APPLICATION NO: 16/2021/1109/ PF

PROPOSAL: Erection of 18 no. dwellings, construction of a new vehicular access and associated works

LOCATION: Land between The Rectory and Brackendene Llanbedr Dyffryn Clwyd Ruthin

APPLICANT: Wheeler Homes

Proposed site layout

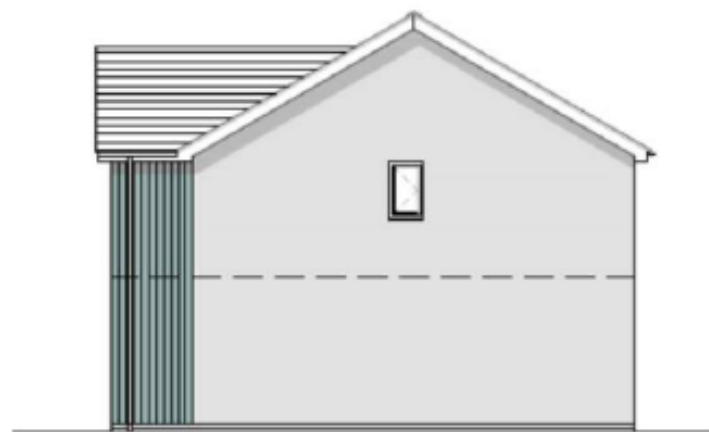
1. We note residents’ concerns that the density means houses very close to the site boundaries, which, due to the contours on the site will overlook existing homes. Reducing the density will help alleviate this.

The site is over-developed. The proposed layout is far too dense and urban in appearance. I would also question the need for a 5.5m width carriageway with footways on both sides for its entire length. The road ends abruptly at the top end of the site. Again, this is a very urbanising feature and could be avoided. This application should be considered on its own merits and not on what might happen in future on adjoining land. I would also question the justification for this width of highway given its intrusion within the layout. It could be reduced to 4.5m and there is no reason for footways on both sides. Why have shared surfaces not been considered as a way of reducing the formality of the layout. At the very least, the highway could fall short of the upper boundary to allow for additional planting etc. In fact the two dwellings on the left hand side at the end, could be served by a private drive.

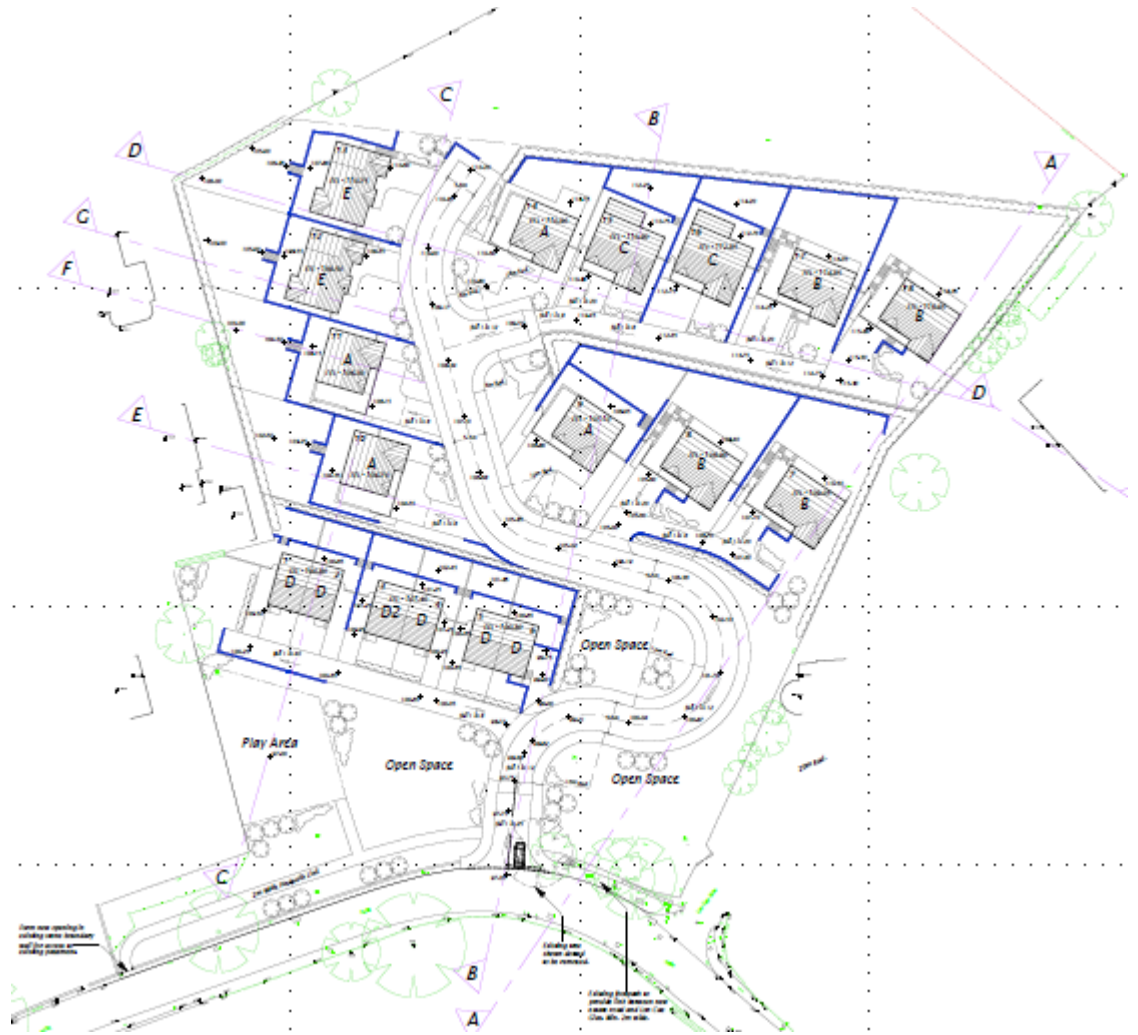
1.1.3 The proposal would also include a significant amount of open space to the front of the site, which would provide informal open space and a play area. Within the open space it is proposed to provide a linking footpath between the eastern and western parts of Llanbedr. This can be seen on the proposed layout plan;

1.1.4 Due to the sloping topography of the site, the dwellings would be built in terraces going up the slope. This will require the construction of retaining walls at various heights and locations. The position of the retaining walls are shown by the blue lines on the above plan.
